ONSITE SEWAGE DISPOSAL SYSTEM

PROPERTY ADDRESS: 1680 Woodstock Road

**OSDS Plan
1680 Woodstock Road
Woodstock, MD 21163**

ON SITE SEWAGE DISPOSAL SYSTEM DESIGN PLAN
LANDS CONVERTED TO
MARIA C ALPRANDO & PRESS PALMER

PRE-CONSTRUCTION:

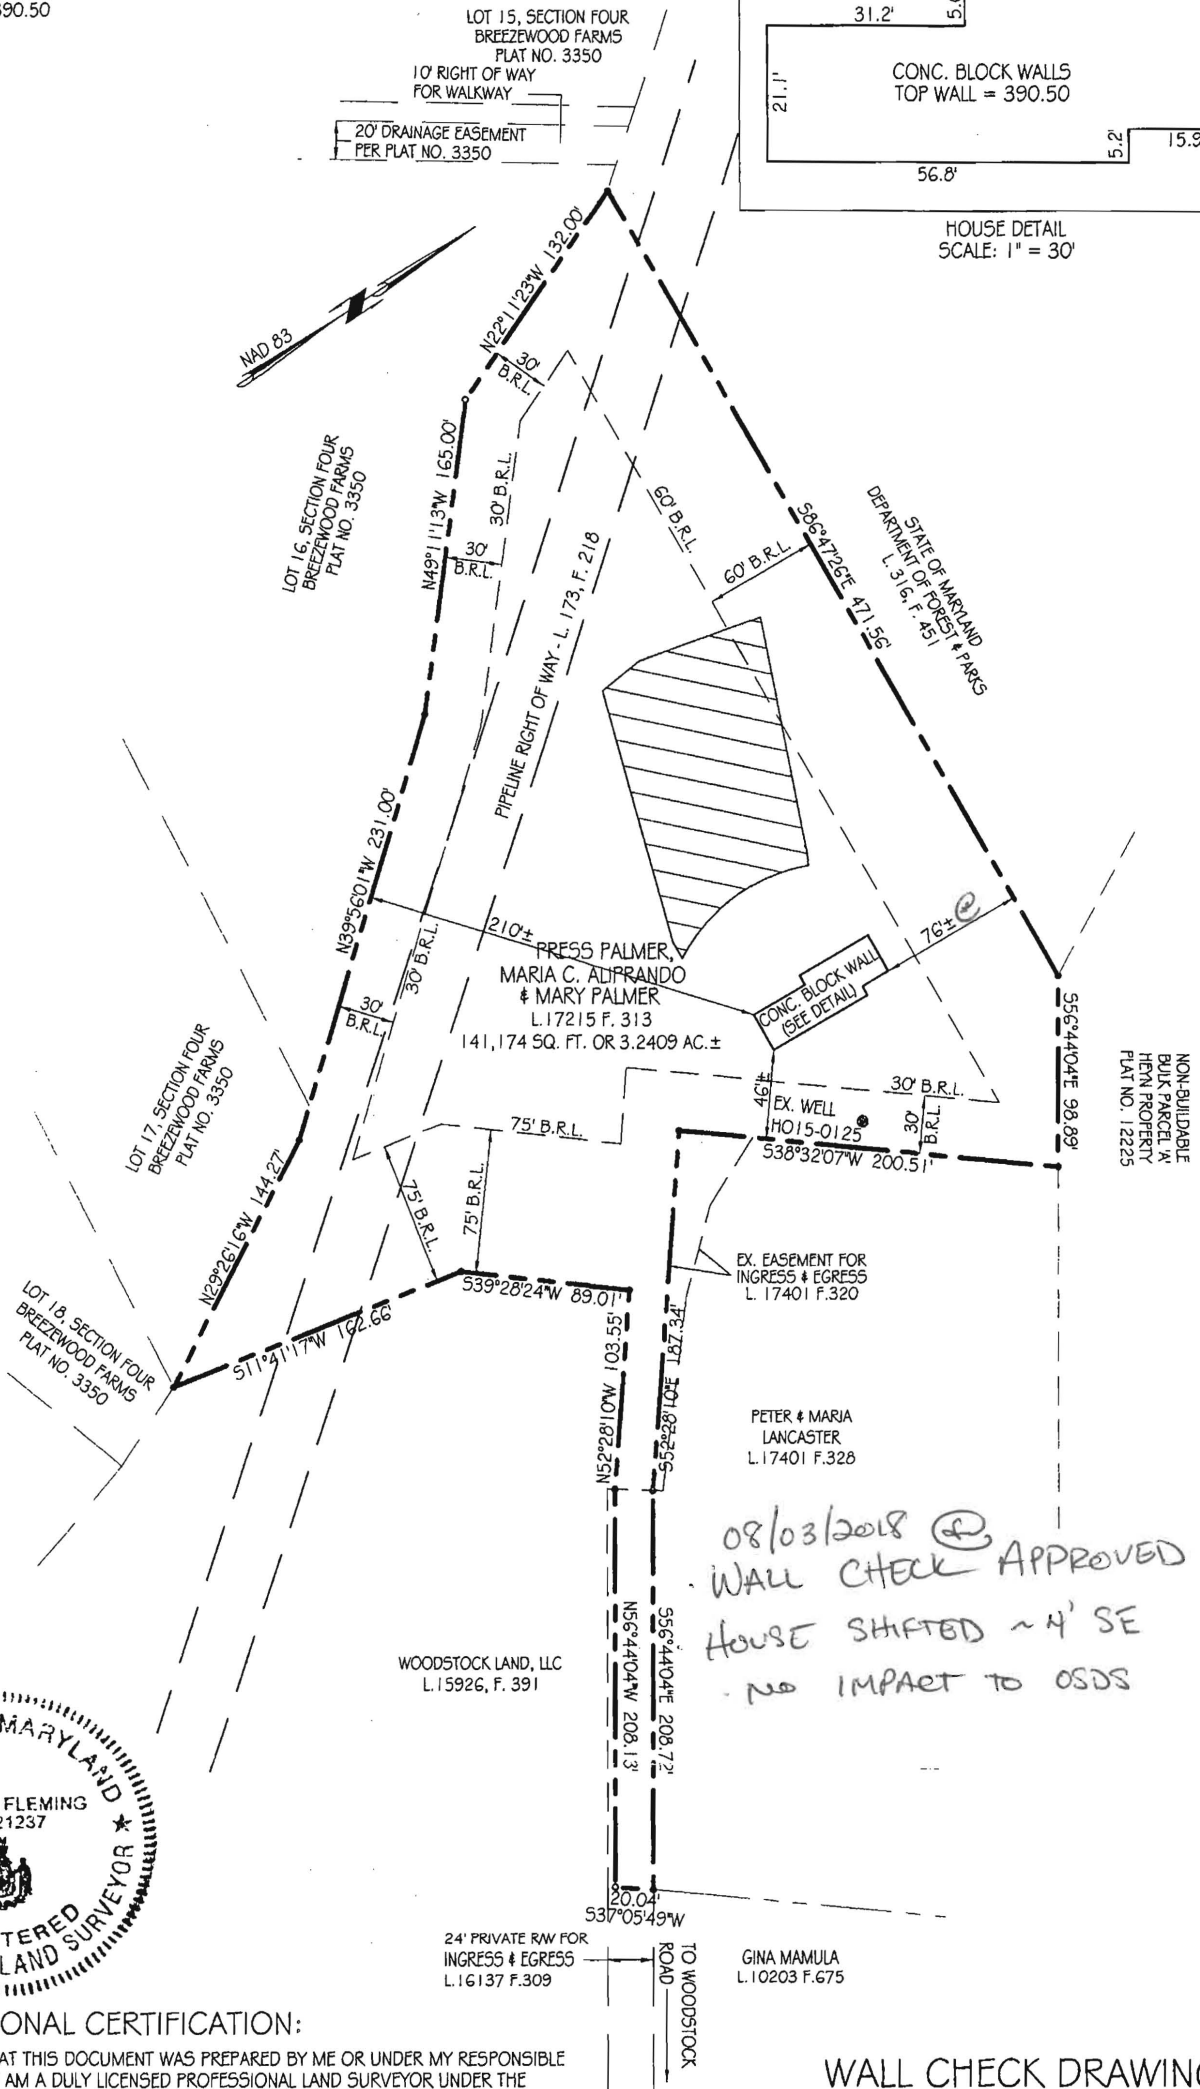
08/03/2018 SDA AND TANK LOCATION STAKED. SHC OUT OF HOUSE WAS DISCOVERED TO HAVE BEEN MOVED CLOSER TO DRIVE WAY IN HOUSE BACK MIDDLE. HOUSE IS 1' HIGHER. TRENCH LAYOUT CLOSE TO TOP OF SDA TO GET OUT OF SWALE IN MIDDLE OF SDA. CONTACT BUILDER FOR GRADE DETAIL. (C)

LINE FROM HOUSE TO TANK. 8/7/18 Trench complete + left open for inspection. 3' wide, 3' to stone. Fogle's said they used a laser to check depths. Start of trench 2.5' off tank. Need grading to fill in swale in SDA prior to final approval of permit. (C) 11/8/18 On site to see if swale in SDA was filled in. Swale is still there - contour is not as shown on plan and future replacement septic trenches will need to be installed to avoid swale. (C)

ON SITE SEWAGE DISPOSAL SYSTEM DESIGN PLAN
LANDS CONVEYED TO

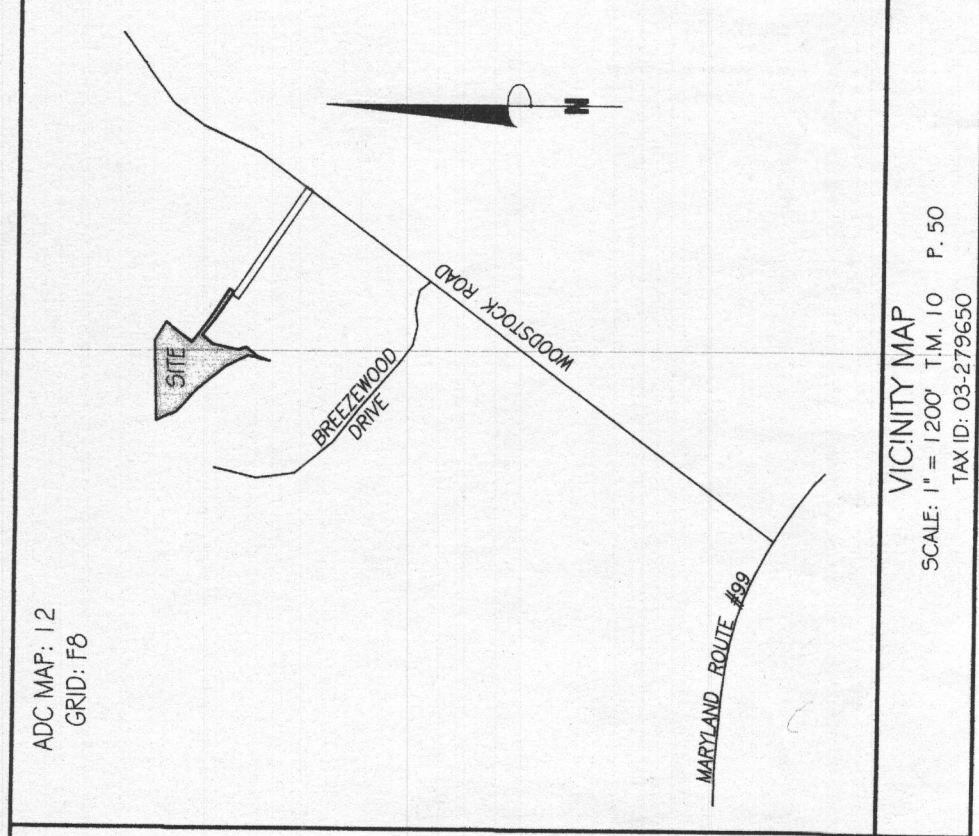
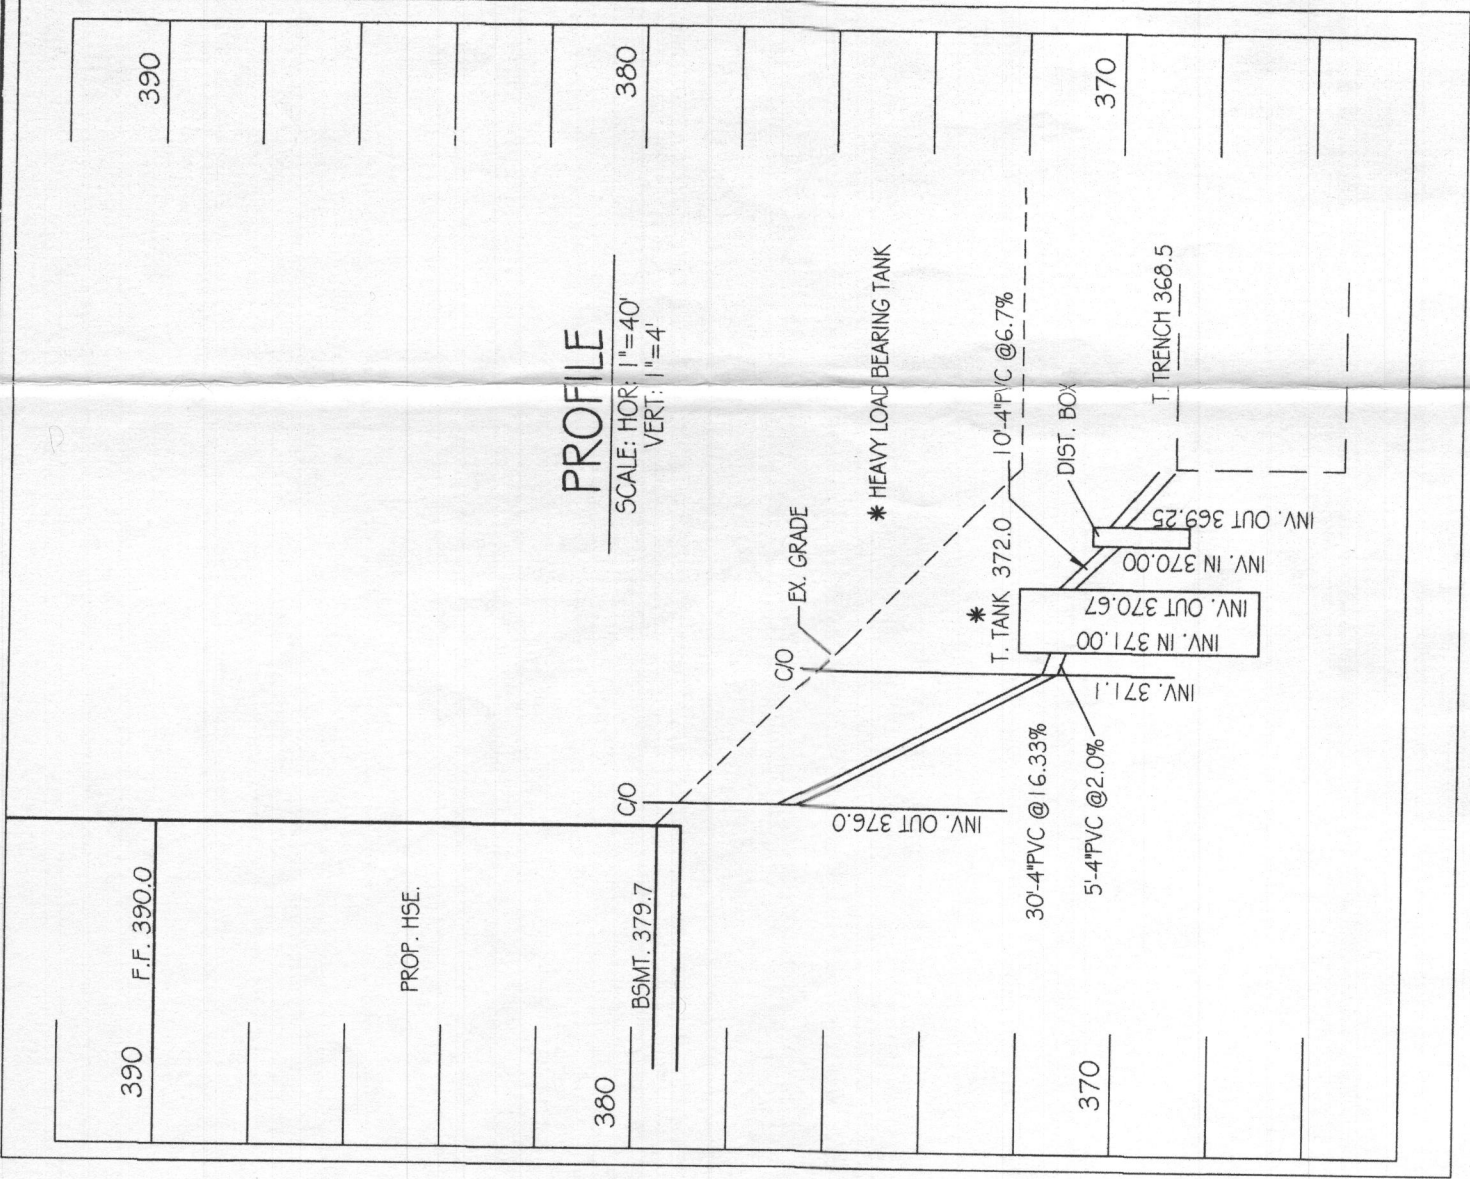
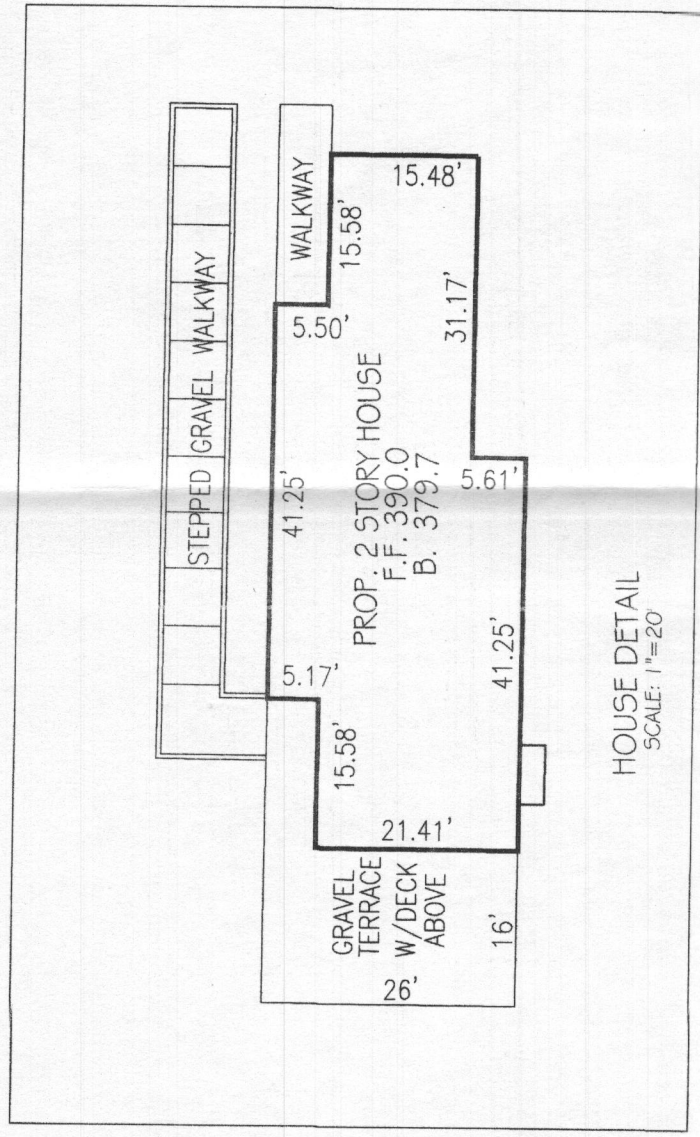
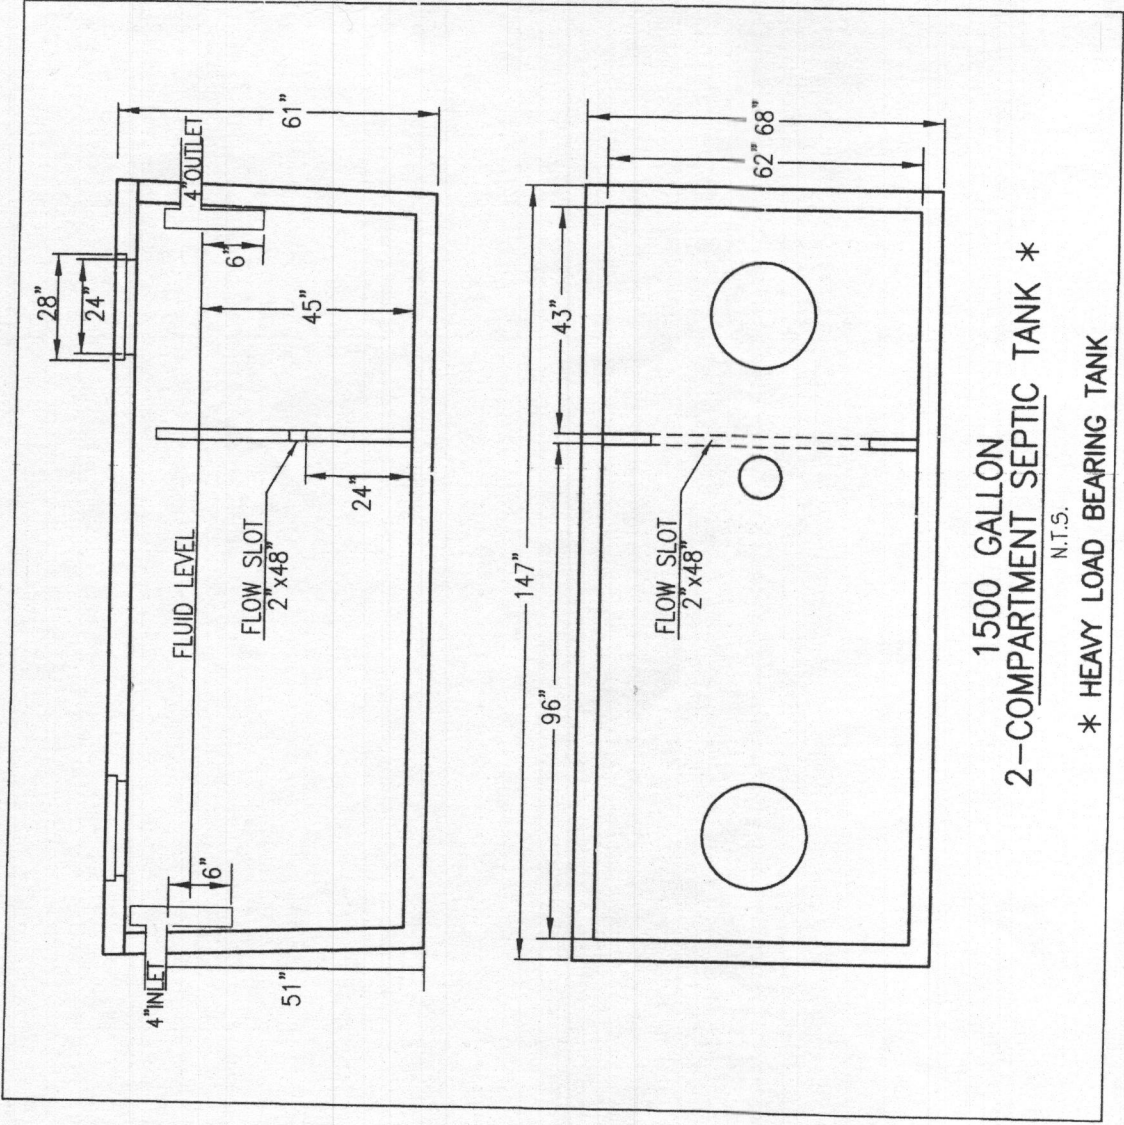
- 1.) The *profile* shows more than 3 feet of cover over the septic tank. Is this a heavy load bearing tank? If so, please indicate on the plan. *Heavy lid note added*
- 2.) The reduction credit for the first replacement should be 0.36 (utilizing 5 foot of sidewall credit). *revised*
- 3.) The grading behind the future garage exceeds 25 %. The setback between steep slopes and the SDA is 25 feet. *changed to less than 25 %*
- 4.) The length of pvc pipe between the house and tank connection is more like 35 feet per *layout* on plan.

Okay. The alternate well sites on the OSDS Plan do not match the alt. well sites on the perc cert plan. Can you revise the OSDS plan so that they do match?

Our office received floor plan revisions to 1680 Woodstock Road. I am starting to look them over now. What's the most recent perc cert plan you have on file for this address? When I looked over the OSDS Plan again, I noticed that the alternate well sites on the perc cert plan signed on 4/15/2011 do not match the well site locations on the OSDS Plan.

REMARKS: Hi Hank, here are the copies, revised to reflect the well sites on OSDS Plan match the Percolation Plan. Have a great day! Mary Anne

1. *The profile shows more than 3 feet of cover over the septic tank. Is this a heavy load bearing tank? If so, please indicate on the plan.* **RESPONSE** – Note added "Heavy Load Bearing Tank".
2. *The reduction credit for the first replacement should be 0.36 (utilizing 5 foot sidewall credit).* **RESPONSE** – Reduction credit revised.
3. *The grading behind the future garage exceeds 25%. The setback between steep slopes and the SDA is 25 feet.* **RESPONSE** – Since this is a fill above the slope, with only drainage from the fill and there is no cut, can this be approved since it will be sheet flow?
4. *The length of pvc pipe between the house and tank connections is more like 35 feet per layout on plan.* **RESPONSE** – The length is 30-ft. between the cleanouts. We consider the distance between the first cleanout and the house to be part of the house plumbing.
